U.S. DEPARTMENT OF
ENERGY

Subject: Transmittal of the Part B Permit Application for Renewal of the Los Alamos National Laboratory Hazardous Waste Facility Permit, EPA ID #NM0890010515

Figure D-2

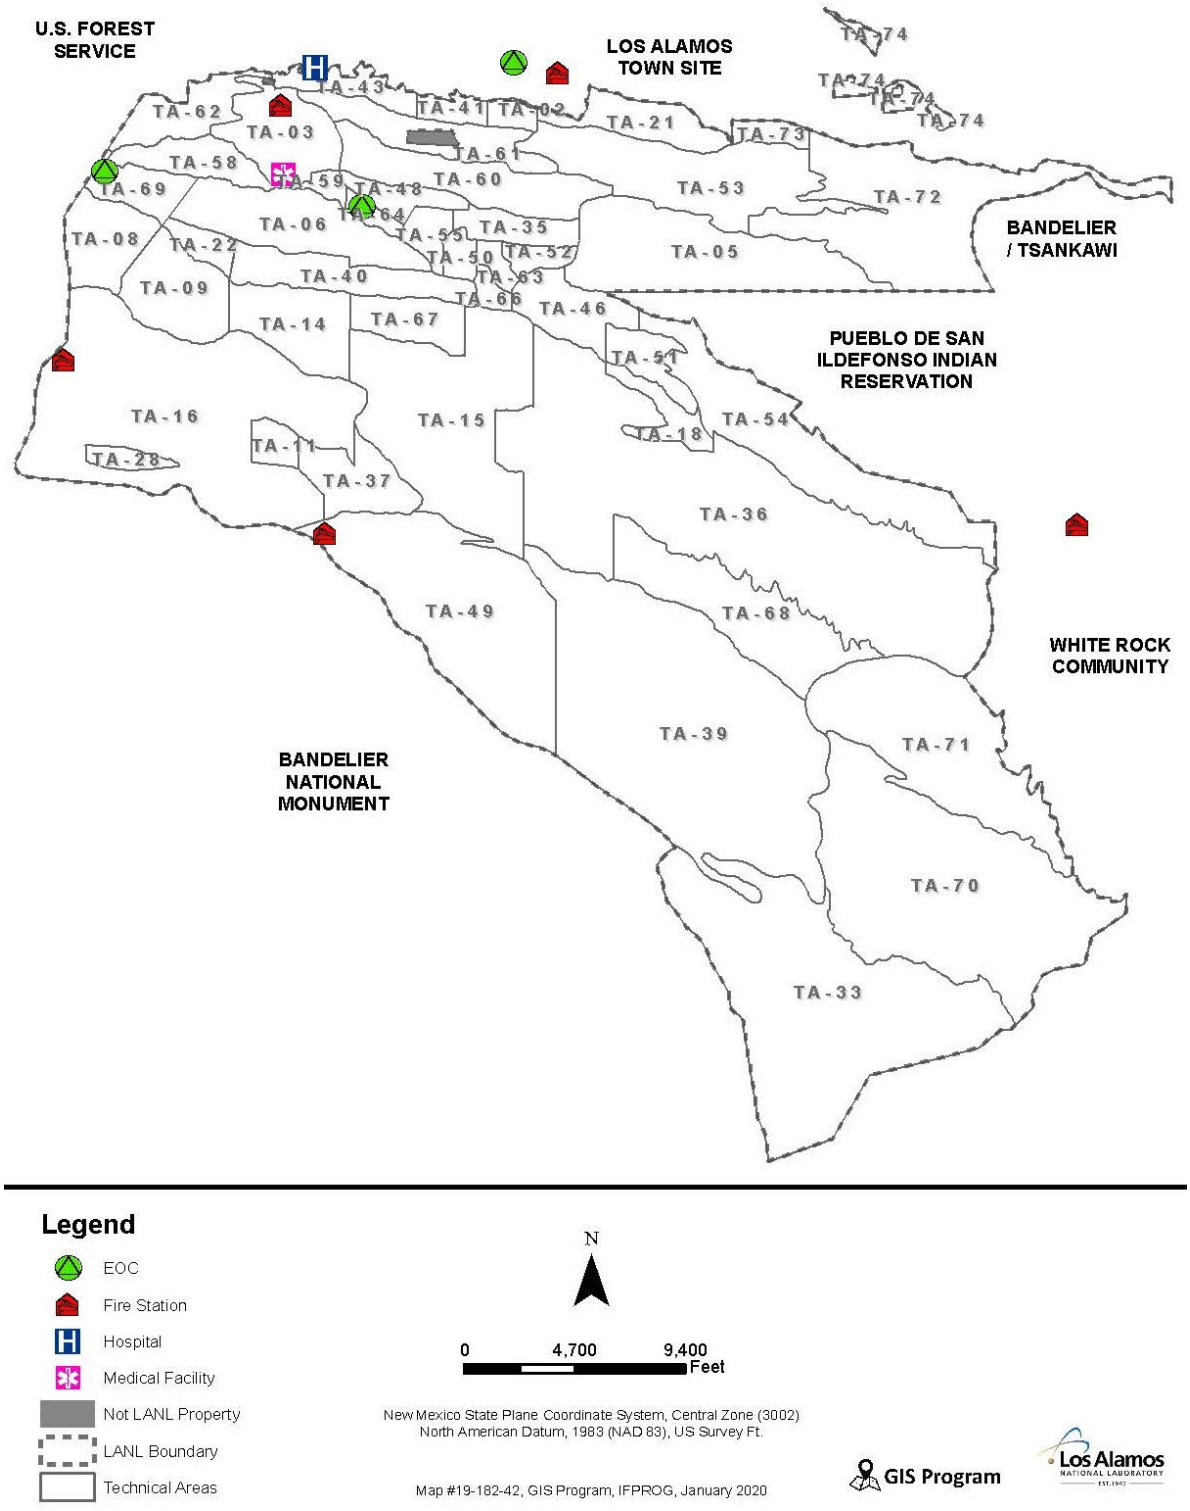
D.1.6.2, Occupational Medicine Personnel	The locations of this and other emergency facilities are shown on Figure D-2, *Emergency Facilities at Los Alamos National Laboratory*~~49 in Attachment N (*Figures*)~~.	The Permittees propose the inclusion of this figure within the contingency plan rather than presenting it separately in Permit Attachment N, because it is more appropriate for the figure to be part of the contingency plan rather than reference a separate attachment of the Permit.
D.2.1, Emergency Equipment	Attachment Tables D-3 through D-15~~TA-3, D-1; TA-50, D-1; TA-54, Area L, D-1; TA-54, Area G, D-2; TA-54 West, D-3; TA-55 Building 4 First Floor, D-1; TA-55 Building 4 Basement, D-2; TA-55 Container Storage Pad, D-3; TA-55-0355 Pad, D-4; and TA-63 Transuranic Waste Facility, D-1~~.	The Permittees propose the rearrangement and renaming of the tables of emergency equipment included within the contingency plan for clarity, to remove inconsistent and redundant information, and to remove subtitle pages within the attachment. The changes proposed in this section reflect proposed revisions later in the contingency plan.

New Figure Number	2010 Permit Figure Number(s)	Proposed Modification	Justification
	Figure 49	Propose to move the figure depicting emergency facilities to Figure D-2, within Attachment D, *Contingency Plan*.	The Permittees propose to include the figure within Attachment D, *Contingency Plan*, rather than include it in Attachment N. It is a more appropriate location and will be easier to locate in an emergency if it is within the contingency plan.

Figure 1 Regional Location Map of Los Alamos National Laboratory (LANL)

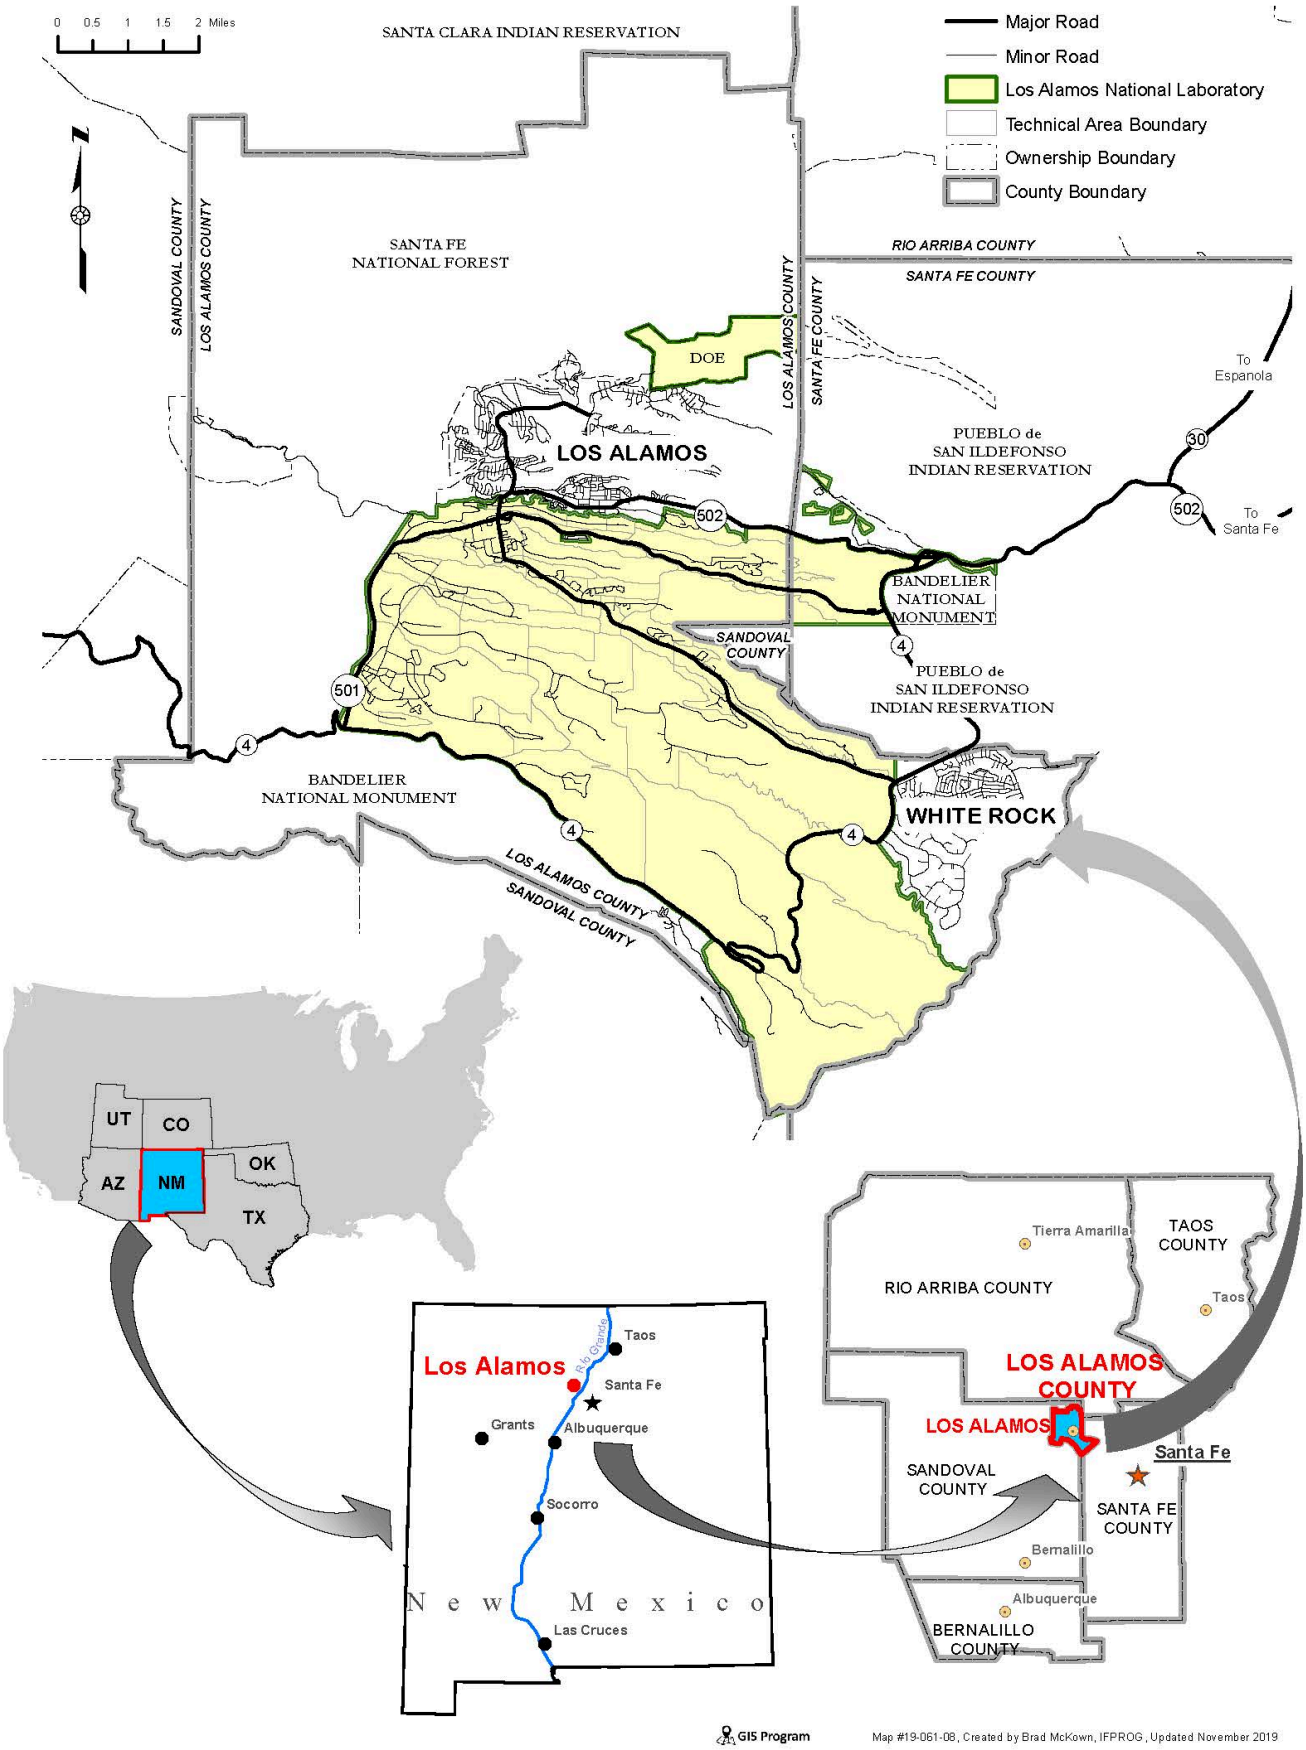
New Figure Number	2010 Permit Figure Number(s)	Proposed Modification	Justification
Figure 1 Regional Location Map of Los Alamos National Laboratory (LANL)	Figure 1	Replace with an updated Figure 1 and update the title of the figure. Update the preferred name of pueblo. Update the legend to distinguish ownership boundaries. General updates to improve the old map.	The Permittees propose to update the contents of the figure to more clearly depict the property boundary of the Facility after consultation with the Pueblo de San Ildefonso Indian Reservation to update their name.
Figure 2 Facility Boundary and Location Map of LANL Technical Areas (TAs)	Figure 2 Replaces Figures 11, 22, 24, 25, 38, & 54	Replace with updated Figure 2 and update the title of the figure. Update the preferred name of pueblo. Added main roads and approximate locations for the current hazardous waste management units so that multiple location figures are not necessary.	The Permittees propose to update the figure with newer content, to improve the old map, and to update the preferred name of the Pueblo. This figure replaces all current location figures within the Permit so as to reduce redundant figures and for ease in updating.

Figure 3 LANL Facility Boundary with Details of Non-LANL Areas

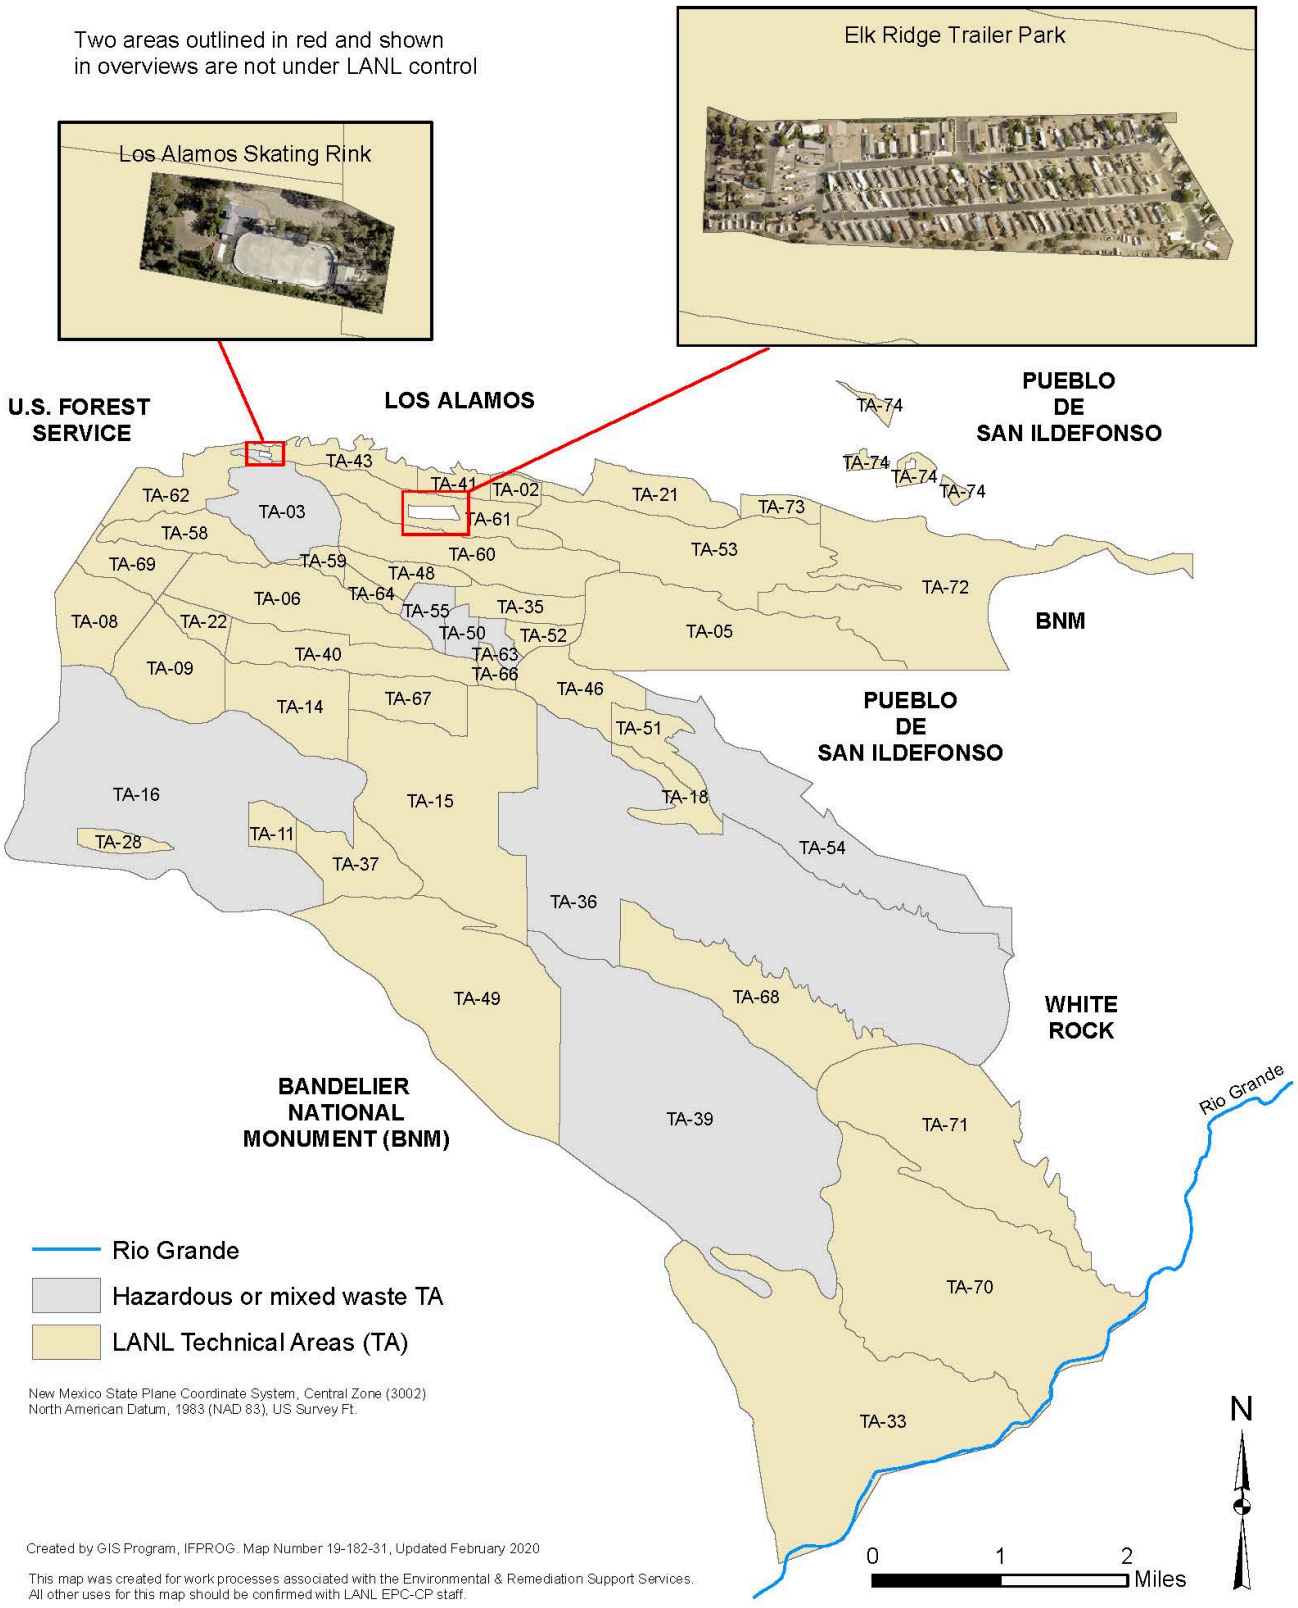
Figure 3 LANL Facility Boundary with Details of Non-LANL Areas	Figure 3	Replace with updated Figure 3 and update the title of the figure. Update the preferred name of pueblo. Update the name of the trailer park from Royal Crest to Elk Ridge.	The Permittees propose to update the figure to provide new information regarding name changes.
Figure 4 TA-3 Location Map Showing Security, Fences, Entry Gates, and Entry Station	Replaces Figure 4 and Figure 12	Update the title of the figure and replace figure with new version.	The Permittees propose an editorial change to the figure title and update to the figure.

Figure 5 TA-16-388 Flash Pad Location Map Showing Security, Fences and Entry Gate

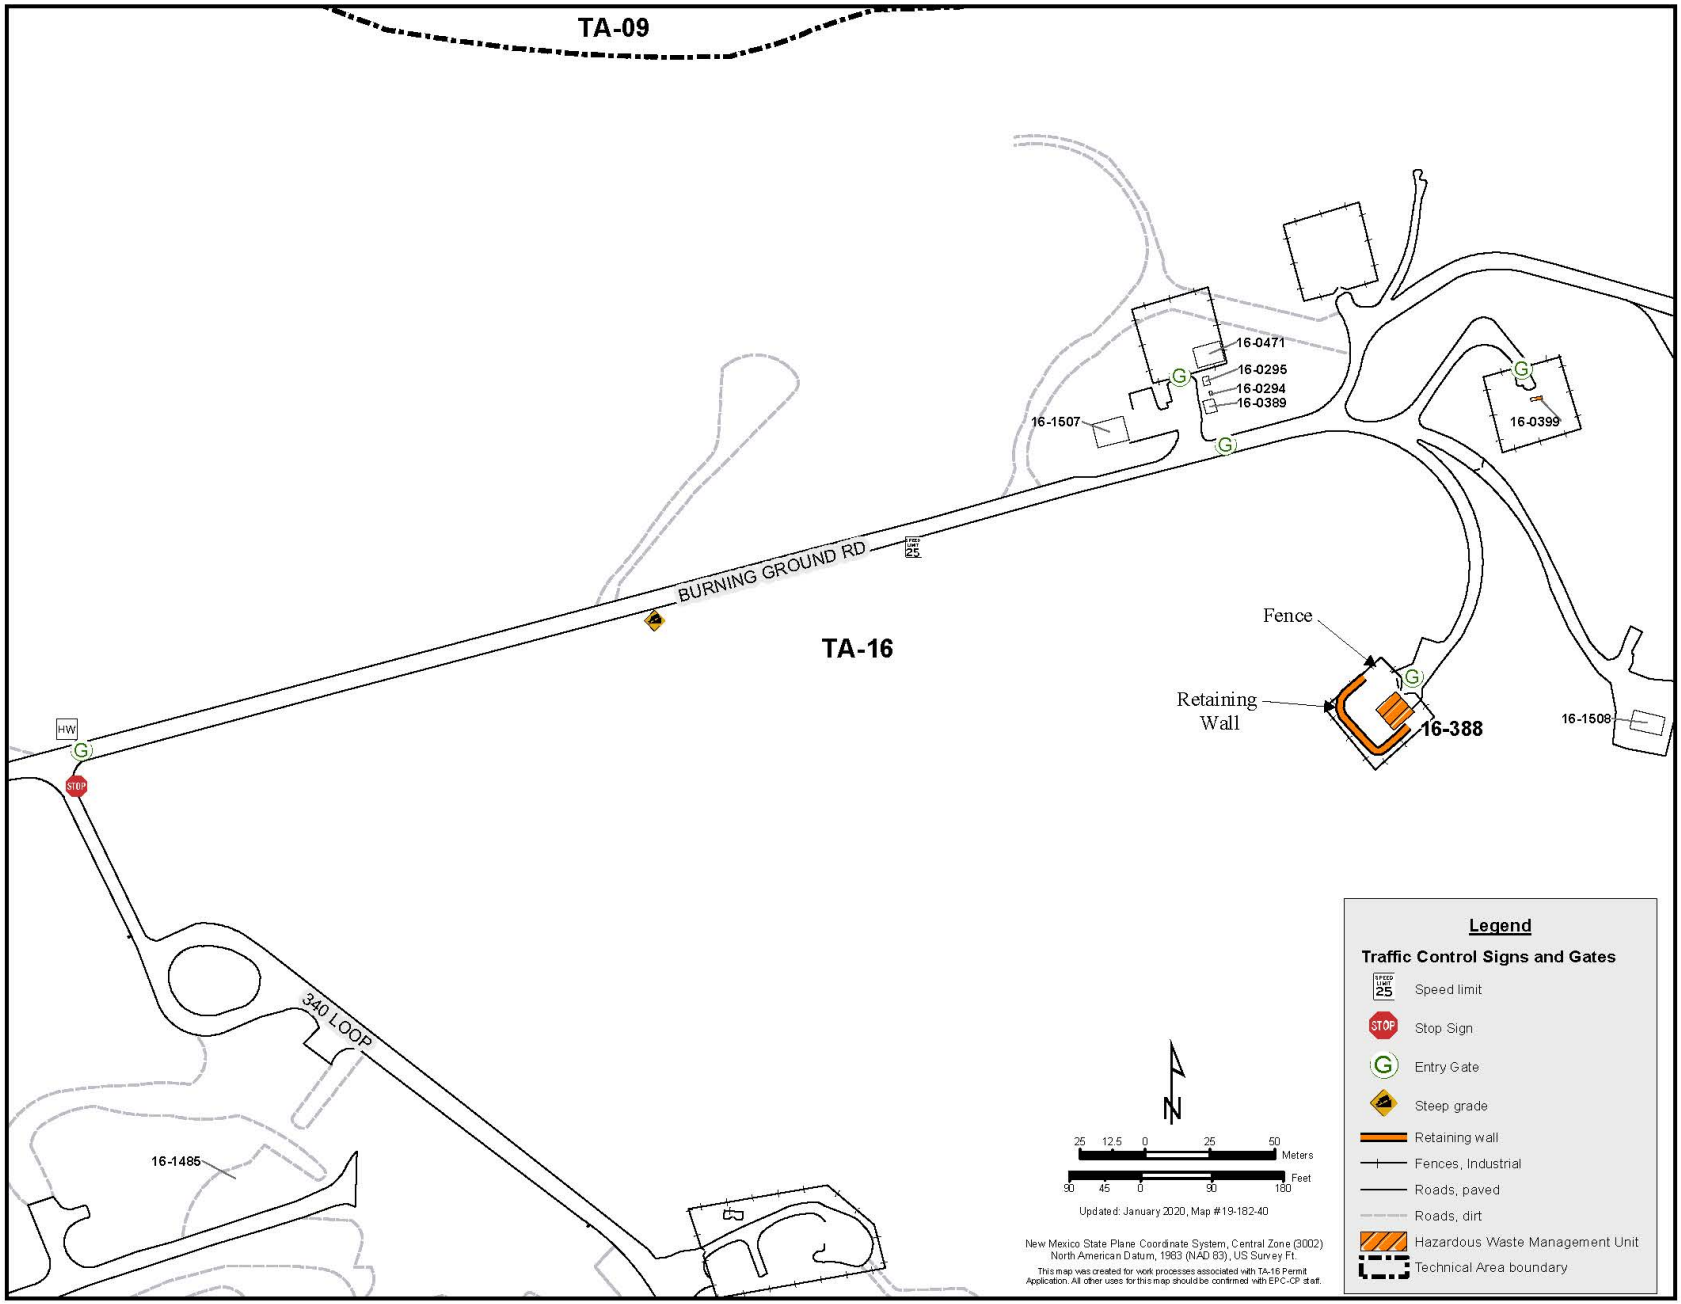
New Figure Number	2010 Permit Figure Number(s)	Proposed Modification	Justification
Figure 5 TA-16-388 Flash Pad Location Map Showing Security, Fences, and Entry Gate	New figure	Propose to insert new Figure 5 to depict the location and security at the TA-16-388 Flash Pad.	The Permittees propose to insert a new Figure 5 to depict the location and security features at the proposed TA-16-388 open burning unit.
Figure 6 TA-36-8 Open Detonation Location Map Showing Security Fences and Entry Gate	New figure	Insert figure to depict the location and security features of the proposed TA-36-8 open detonation unit.	The Permittees propose to move the current 2010 Permit Figure 6 to a new Figure 8 (TA-50 security features, see below). The Permittees propose to change Figure 6 to depict the security at the proposed TA-36-8 open detonation unit.
Figure 7 TA-39-6 Open Detonation Location Map Showing Security Fences and Entry Gate	New figure	Insert a new Figure 7 for the location and security at the proposed TA-39-6 open detonation unit.	Propose to move Figure 7 (TA-54, Area L, location and security features) in the current 2010 Permit, to new Figure 9 for consistency. The Permittees propose new Figure 7 to depict the location security features at the proposed open detonation unit TA-39-6.
